SUNDRY NOTICES AND REPORTS ON WELLS
Do not use this form for proposals to drill or to re-enter an abandoned well. Use form 3160-3 (APD) for such proposals.

Plug and Abandonment Procedure

Buena Suerte 4 Com 1T

API # 30-045-32007

Proposed Wellbore P&A Diagram
DJR Operating, LLC
Buena Suerte 4 Corn 1T
API # 30-045-32007
SW/NW, Unit E, Sec 4, T25N, R11W
San Juan County, NM

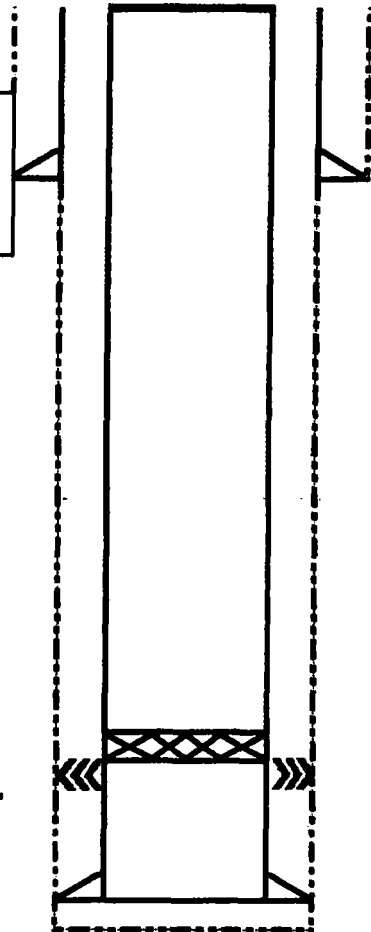
- Please ensure that the tops of the Pictured Cliffs and Fruitland formations as well as the entire Ojo Alamo aquifer, identified in this report, are isolated by proper placement of cement plugs. This will protect the freshwater sands in this well bore.
